Informal document GRE-85-15
85th GRE, 26-29 October 2021
Agenda item 4 (d)

Correction of errors in the proposal for the 01 series of amendments to UN Regulation No. 150 (Retro-reflective devices)

The text reproduced below was prepared by the GRE Informal Working Group on Simplification of Lighting and Light-Signalling Regulations (IWG SLR) with the aim to correct some errors identified in the proposal for the 01 series of amendments to UN Regulation No. 150 (doc. ECE/TRANS/WP.29/GRE/2021/15).

“Figure A5-X

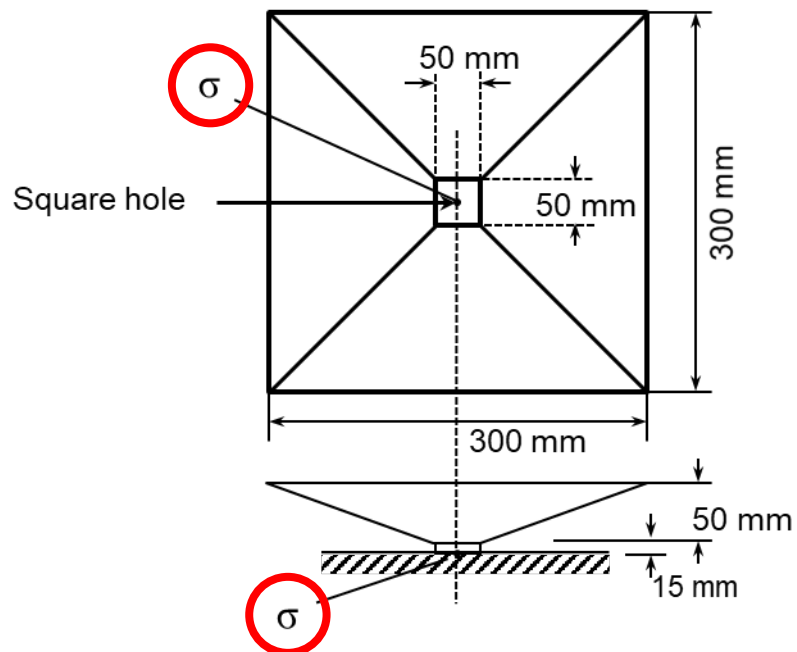
Figure A5-X, amend the title and replace the figure as follows:

Shape and dimensions of the advance warning triangle of type 2 and of the support Test apparatus for clearance to ground

11. In Figure A5-X the title has been corrected. The centre of the square hole was indicated by mistake with a “0” (zero) instead of “σ” (sigma). This has now been corrected and aligned with the text of paragraph 1.1.2. of Annex 9.
